Orchards at Orenco Passive House Construction

ORCHARDS AT ORENCO - PHASE I
 NW 231ST AVENUE & CHERRY DRIVE HILLSBORO, OREGON

THE ORCHARDS AT ORENCO STATION PHASE 1
 DD SET
 SEPT 2013

Photo #1
Metal "L" angle sill dam requires secure attachment to opening sill

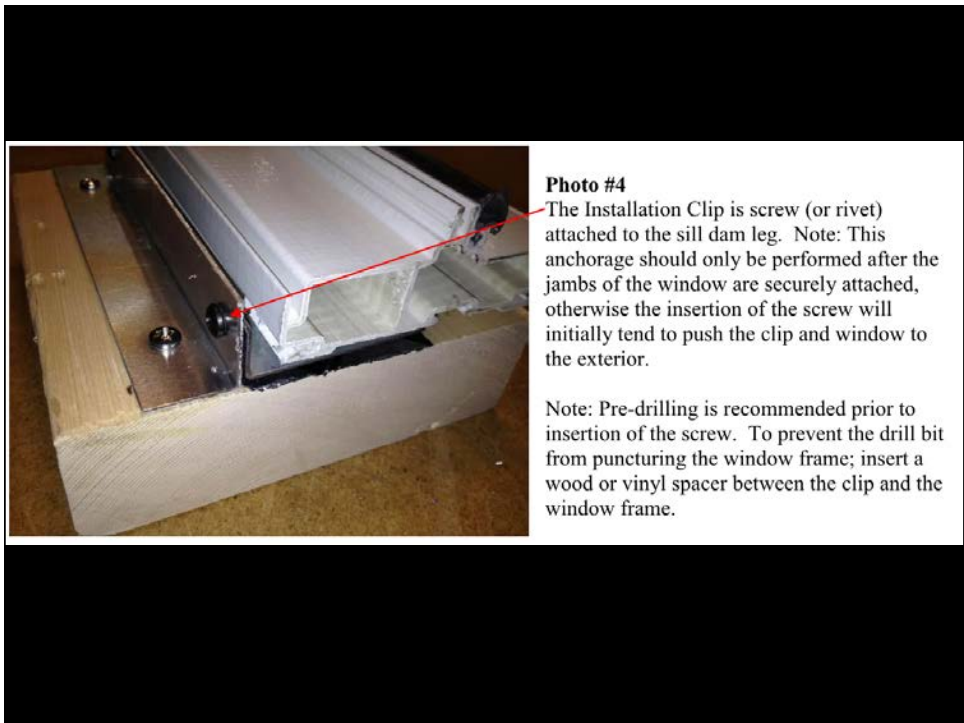
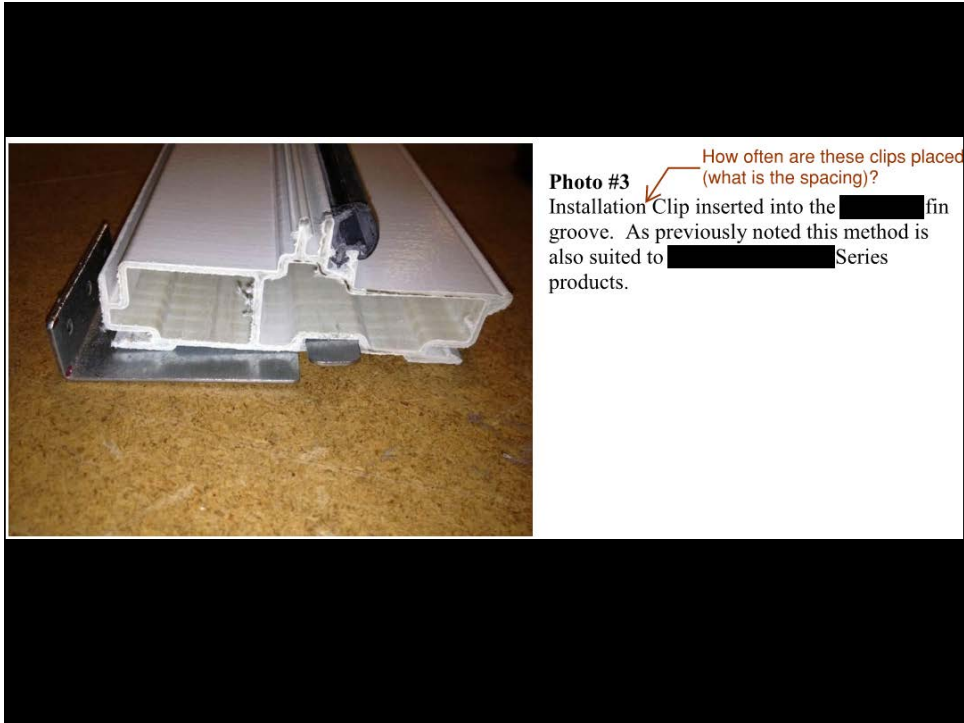
Are we required to use foil faced material?

Photo #2
Standard Installation Clip is cut to length and then bent 90°. The clip length will need to be determined per job as it is based on the width of the joint between the sill dam and the window plus the leg height of the sill dam.

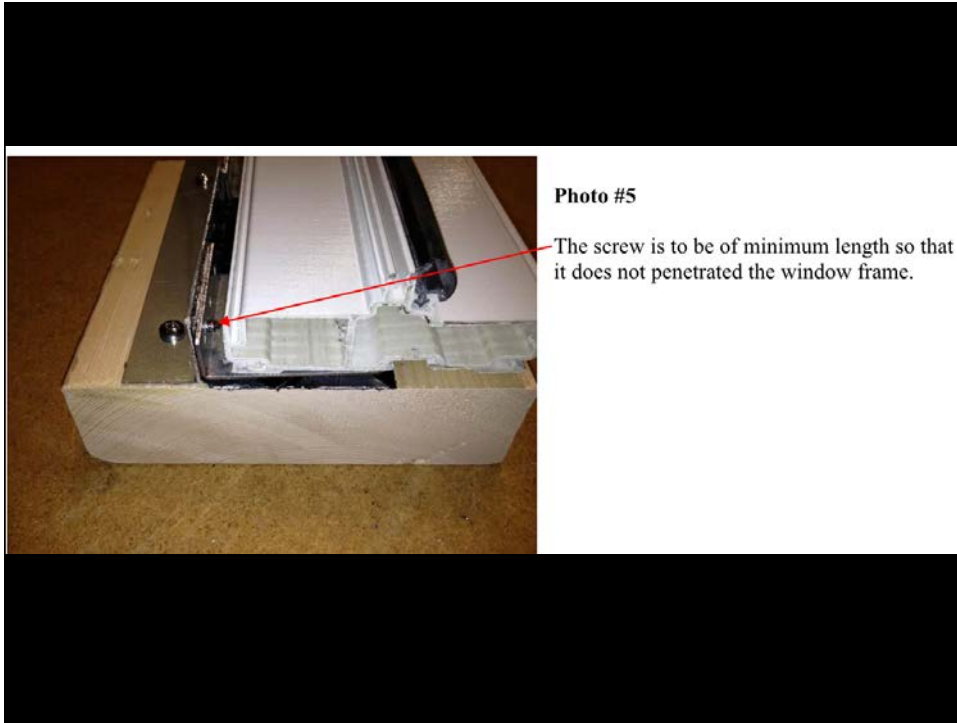
Is this bent in the factory or in the field?

5 RADON VENT AT SLAB

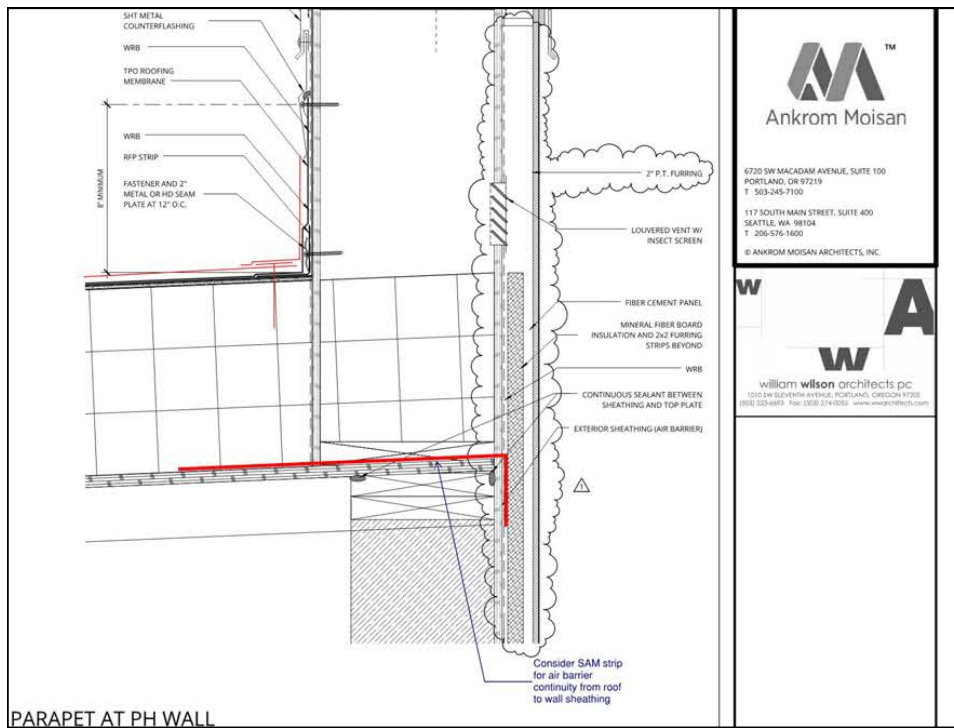
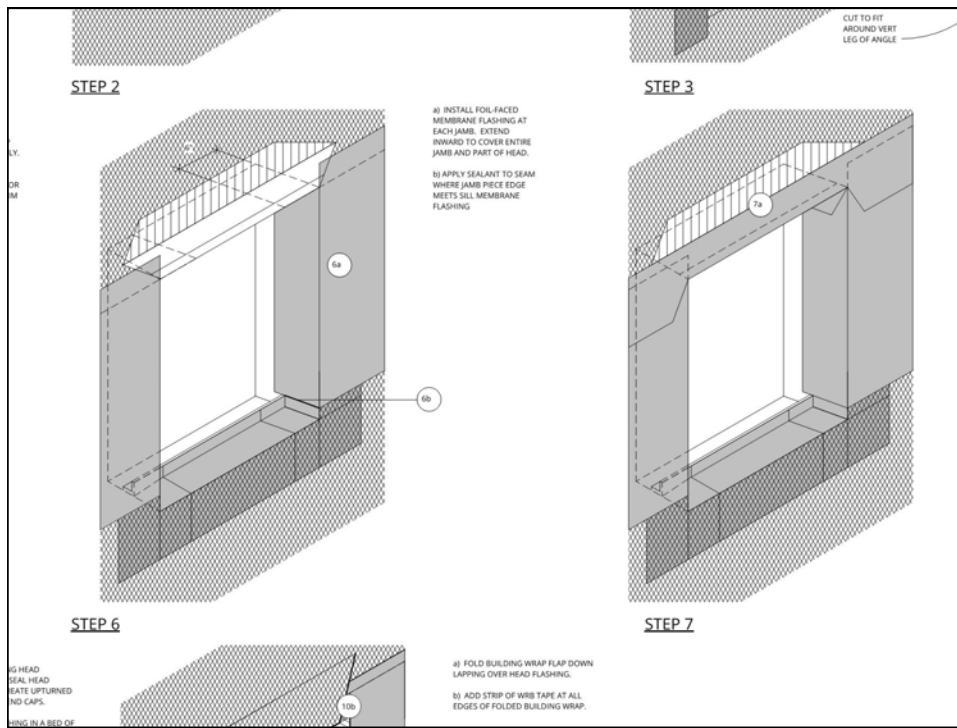
doesn't make much sense. Please consider extending sheathing to bottom of plate so that fewer transitions in SAM are required. SAM is not in contact with sheathing- how is this detail air tight?
